Road Safety Audit Review

| Town:  | Colchester           | Date Reviewed: | July 13, 2015   |
| Route: | US 2 at Exit 17 Ramp | Mile points:   | US 2: 1.86-2.11 |

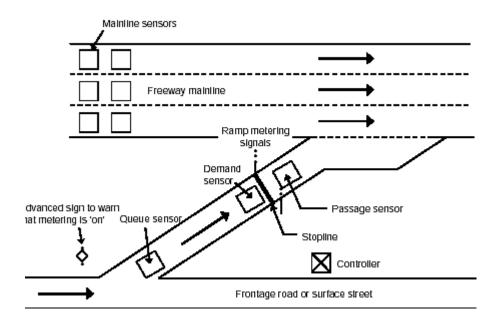
There is an important crash pattern at the southbound on ramp signal involving left turn motorists and eastbound motorists. In most cases, the left turning motorists are not yielding to oncoming traffic when they are facing a green ball.

If a protected only left turn phase is not desirable due to extreme delays, replace the five-section head with a flashing yellow arrow four-section head to improve understanding by motorists.

A long term measure would be to eliminate the left turning movement onto the southbound off ramp. One approach would be to construct the new southbound on ramp that is suggested by the Exit 17 Scoping Study and that would require motorists to go through the signal and continue right onto the ramp.
